dsPIC33EPXXXGM3XX/6XX/7XX Family Silicon Errata and Data Sheet Clarification

The dsPIC33EPXXXGM3XX/6XX/7XX family devices that you have received conform functionally to the current Device Data Sheet (DS70000689D), except for the anomalies described in this document.

The following typographic corrections and clarifications are to be noted for the latest version of the device data sheet (DS70000689D):

FIGURE 1: TIMING DIAGRAMS FOR CENTER-ALIGNED AND EDGE-ALIGNED MODES

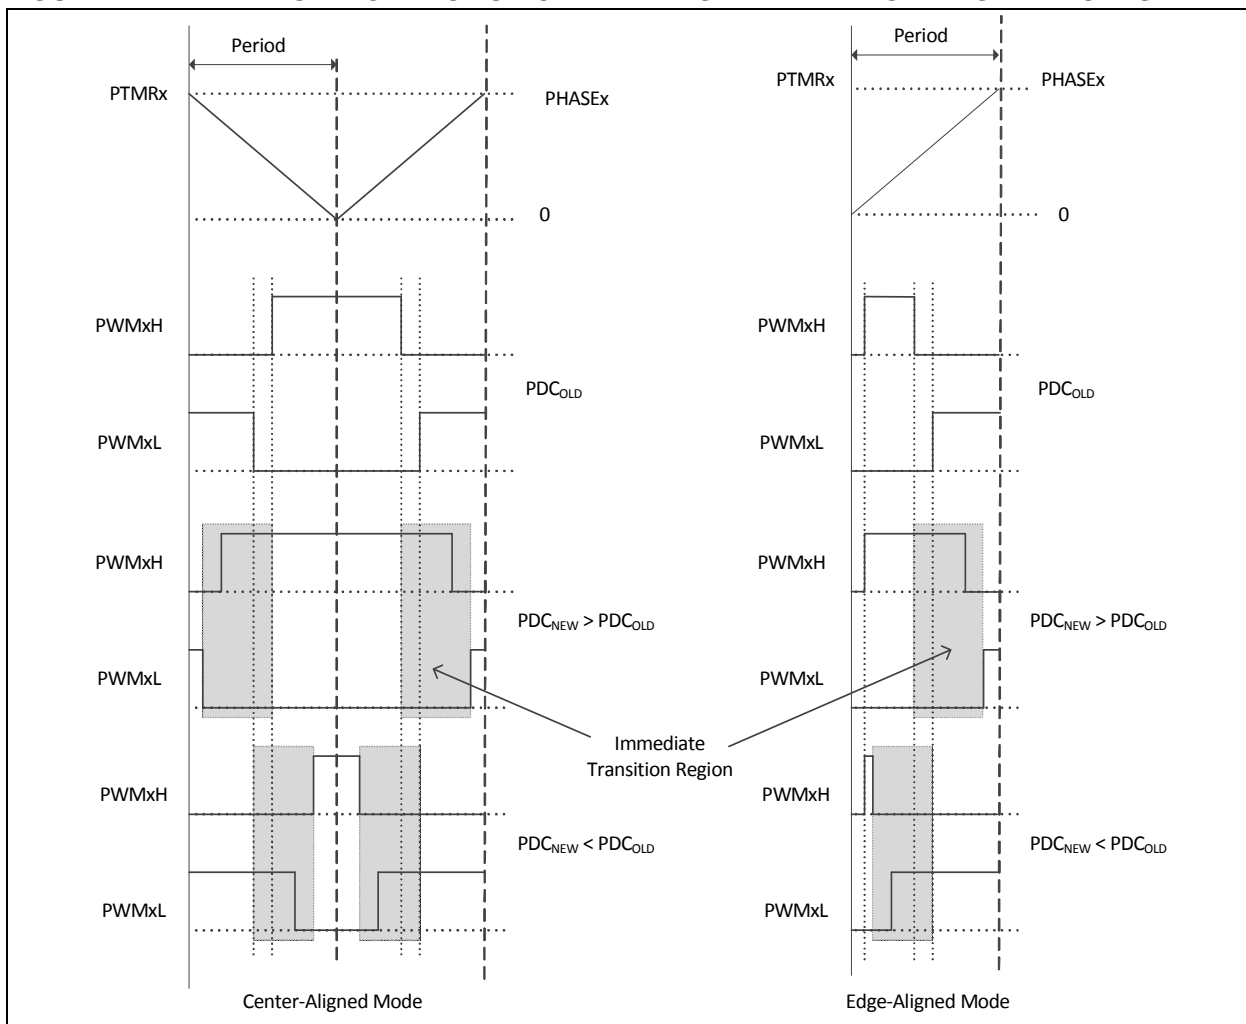
The PWM generator may not assert dead time on the edges of transitions. This has been observed when all of the following conditions are present:

- The PWM generator is configured to operate in Complementary mode with Independent Time Base (ITB) or master time base;
- Immediate update is enabled; and
- The value in the PDC register is updated in such a manner that the PWMxH and PWMxL outputs make an immediate transition.

In **Figure 1**, if the duty cycle write occurred in the shaded box, then PWMxH and PWMxL will make an immediate transition without dead time.

In most applications, the duty cycle update timing can be controlled using the TRIGx trigger, or Special Event Trigger, such that the above mentioned conditions are avoided altogether.

FIGURE 2: PWM GENERATOR TIMING DIAGRAM

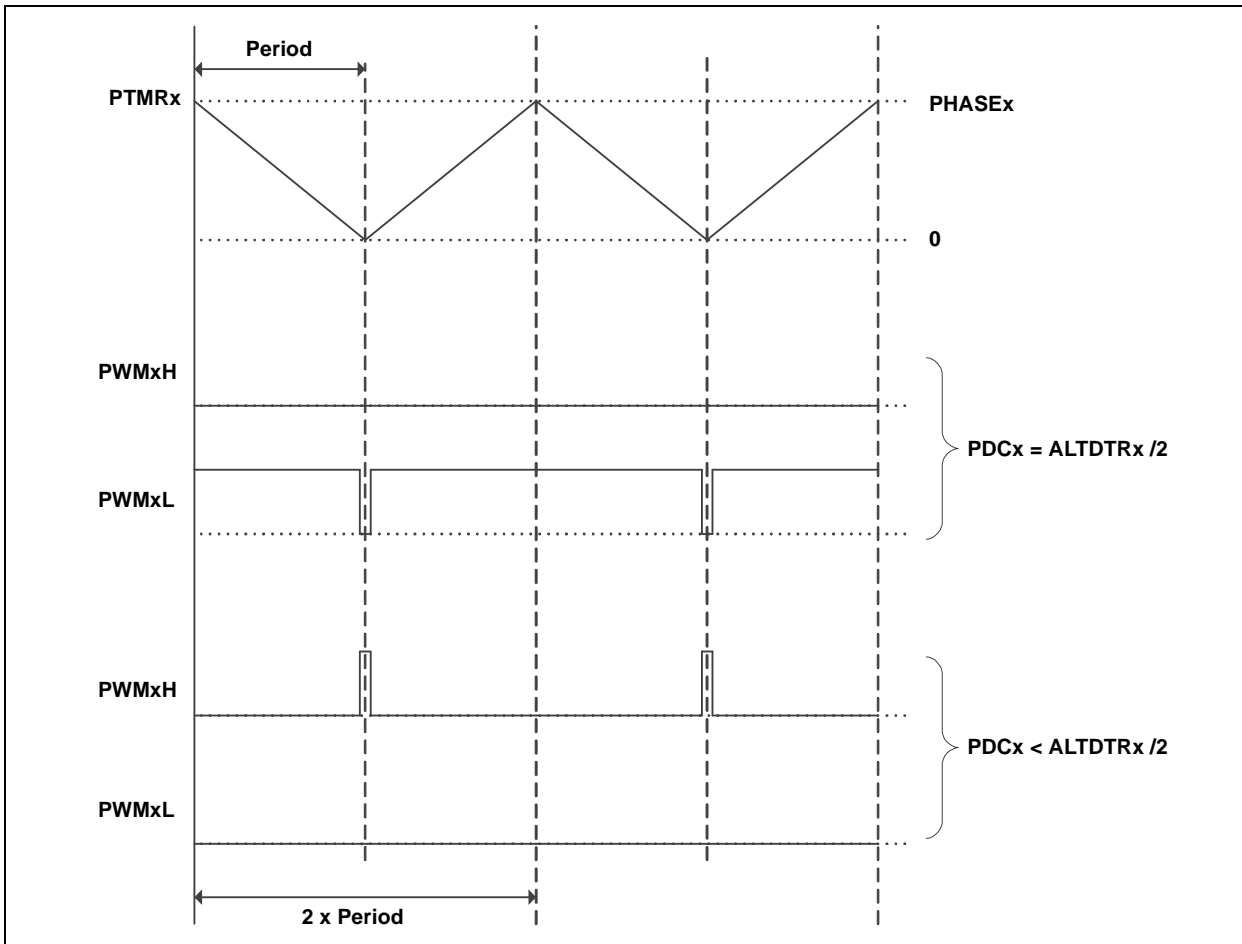
In Center-Aligned Complementary mode with Independent Time Base, if the value in the PDCx register is less than one-half the value in the ALTDTRx register, the PWM generator will force the PWMxL to low, and on the PWMxH, generates pulses of a width less than twice the dead time, as shown in Figure 2.

Include a software routine to ensure that the duty cycle value written to the PDCx register is at least one-half of the value in ALTDTRx. Example 1 shows one method, with PDCtemp representing the variable which has the value to be written to the PDCx register. Alternatively, for duty cycle values less than half the desired dead-time value, zero out the ALTDTRx register or dynamically reduce the value in the ALTDTRx register, such that ALTDTRx is always equal to 2 * PDCx, as shown in Example 2.

FIGURE 3:

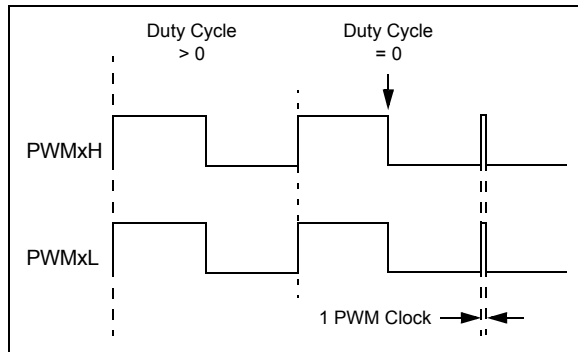
In certain output modes, the PWMx module produces a pulse glitch of one PWM clock in width (Figure 3). This has been observed only when all of the following are true:

- Either Redundant or Push-Pull Output mode is selected ($\text{IOCONx}\langle 11:10 \rangle = 10$ or 01);
- Immediate Update is disabled ($\text{PWMCONx}\langle 0 \rangle = 0$); and
- The value of the current Duty Cycle register (either the PDCx or MDC register, as determined by $\text{PWMCONx}\langle 8 \rangle$) is updated to zero from any non-zero value.

The pulse glitch has been observed to occur at the beginning of the following PWM boundary period.

If the application requires a duty cycle of zero, two possible work arounds are available.

1. Use the PWM overrides to force the output to a low state, instead of writing a '0' to the Duty Cycle register. When using this method, the PWM override must be disabled when the duty cycle is a non-zero value. If output override synchronization is configured to occur on CPU clock boundaries ($\text{IOCONx}\langle 0 \rangle = 0$), enabling and disabling the override must be timed to occur as closely as possible to the PWM period boundary.
2. Configure the module for Immediate Update ($\text{PWMCONx}\langle 0 \rangle = 1$) before enabling the module. In this mode, writes to the Duty Cycle register have an immediate effect on the output. As with the previous work around, writes to the Duty Cycle register must be timed to occur as close to the PWM period boundary as possible in order to avoid distortion of the output.

FIGURE 4:

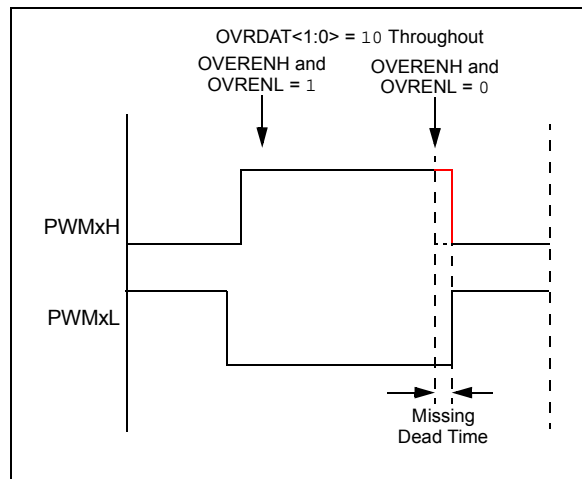
In Complementary Output mode, the expected dead time between transitions of the PWMxH and PWMxL outputs may not be asserted when the following occurs:

- Output override synchronization is configured to occur on the CPU clock boundary ($\text{IOCONx}\langle 0 \rangle = 0$);
- Both PWMxH and PWMxL overrides are enabled prior to the event (OVRENH and OVRENL are both '1'), and
- Both overrides are disabled (OVRENH and OVRENL are both '0') at the instant the dead time should be asserted (Figure 4).

This has been observed in both Center-Aligned and Edge-Aligned modes.

FIGURE 5:

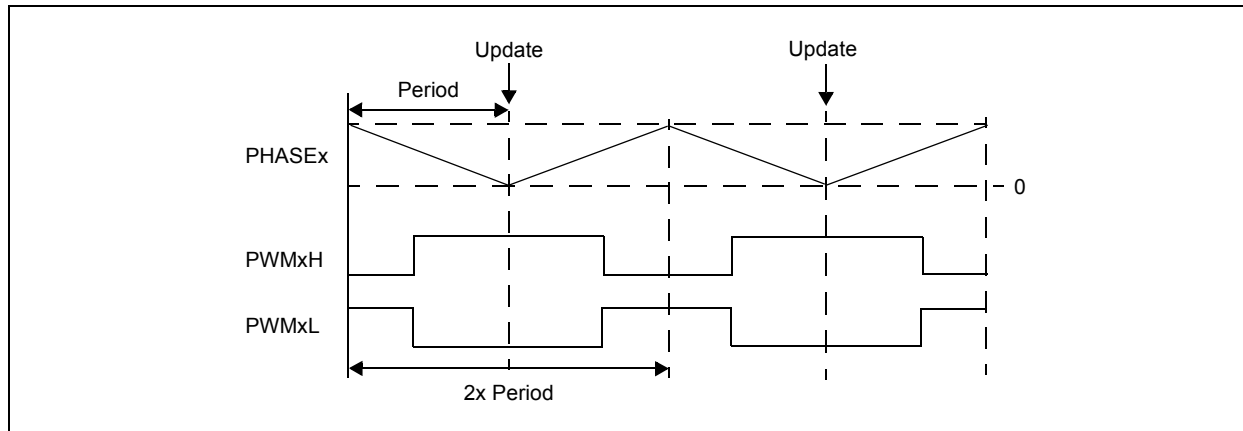
In Center-Aligned Complementary mode with Independent Time Base, updates to the PHASEx register take effect in the middle of a Center-Aligned PWM cycle, as shown in Figure 5. This occurs only when the Immediate Update feature is disabled (IUE = 0). If Immediate Update is enabled (IUE = 1), the PHASEx register updates will take effect immediately.

FIGURE 6:

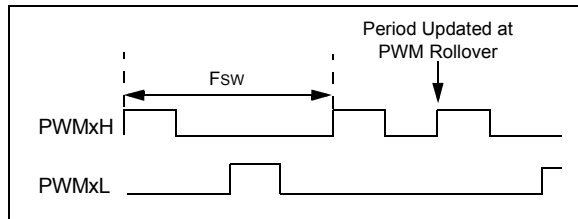
When the PWM module is configured for Push-Pull mode (IOCONx<11:10> = 10) with the Enable Immediate Period Update bit enabled (PTCON <10> = 1), a write to the Period register that coincides with the period rollover event may cause the push-pull output logic to produce back-to-back pulses on the PWMx pins (Figure 6).

Ensure that the update to the PWM Period register occurs away from the PWM rollover event by setting the EIPU bit (PTCON<10> = 1). Use either the PWM Special Event Trigger (SEVTCMP) or the PWM Primary Trigger (TRIGx) to generate a PWM Interrupt Service Routine (ISR) near the start of the PWM cycle. This ISR will ensure that period writes do not occur near the PWM period rollover event.

FIGURE 7: SIMPLIFIED BEHAVIOR

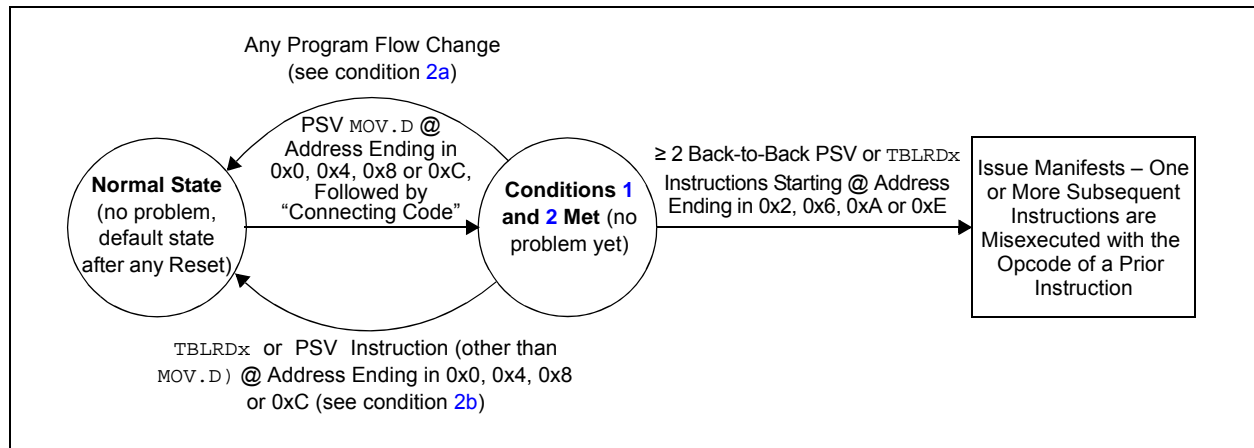
3.	≥ 2 back-to-back PSV or TBLRDx instructions are executed (following the code of condition 2), where the first of the back-to-back instructions is located at an address ending in 0x2, 0x6, 0xA or 0xE.

[Figure 7](#) provides an example of the effective behavior.

1. All instances of PSV `MOV.D` can be replaced with two PSV `MOV` instructions instead. Non-PSV `MOV.D` instructions acting on RAM/SFRs do not need to be modified; or
2. If not already present, a program flow change instruction (such as `BRA $+2`) can be inserted above back-to-back data Flash read sequences; or
3. Back-to-back data Flash read instruction sequences can be broken up by inserting a non-Flash read instruction (such as a `NOP`), in between the Flash read instructions; or
4. The alignment of the code can be shifted to avoid the required opcode location addresses.

C code built with MPLAB® XC16 Compiler Version 1.32, or later, implements the work around by default. However, if the application uses Assembly language routines, these should be manually modified to implement the work around. Additionally, if precompiled libraries are used, these should be built with XC16 Version 1.32 or later. For additional information, please visit: www.microchip.com/erratum_psrds_psrds

64-Lead Plastic Quad Flat, No Lead Package (MR) – 9x9x0.9 mm Body with 5.40 x 5.40 Exposed Pad [QFN]

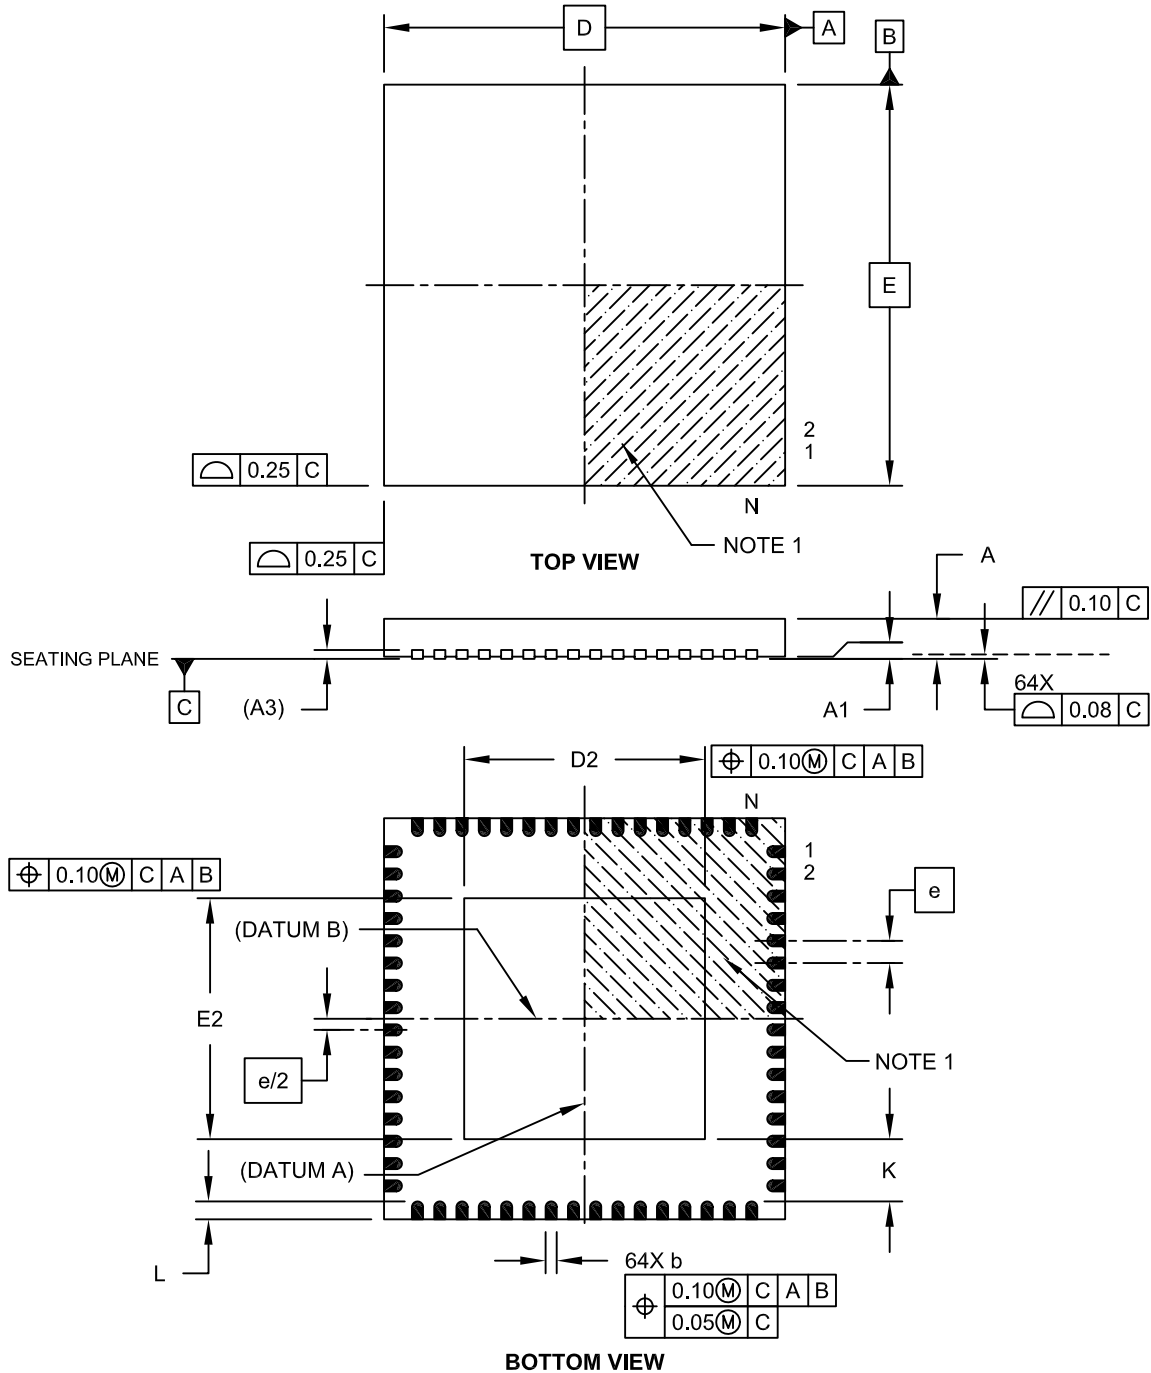
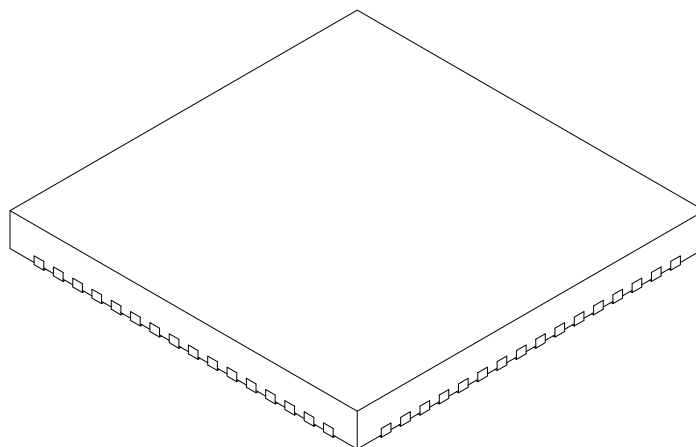
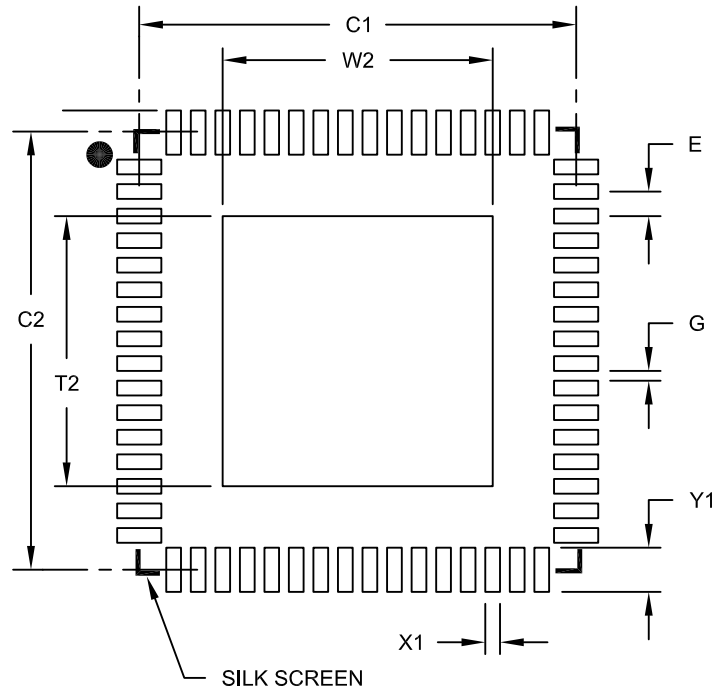
In the “dsPIC33EPXXXGM3XX/6XX/7XX Family Data Sheet”, **Section 35.2 “Package Details”**, dimensions for the 64-Lead Plastic Quad Flat, No Lead Package (MR) – 9x9x0.9 mm Body with 7.15 x 7.15 Exposed Pad [QFN] is mentioned. However, the dsPIC33EPXXXGM3XX/6XX/7XX family devices are not available in this package.

The dsPIC33EPXXXGM3XX/6XX/7XX family devices are available in the 64-Lead Plastic Quad Flat, No Lead Package (MR) – 9x9x0.9 mm Body with 5.40 x 5.40 Exposed Pad [QFN], and the package dimensions are shown on the following pages.
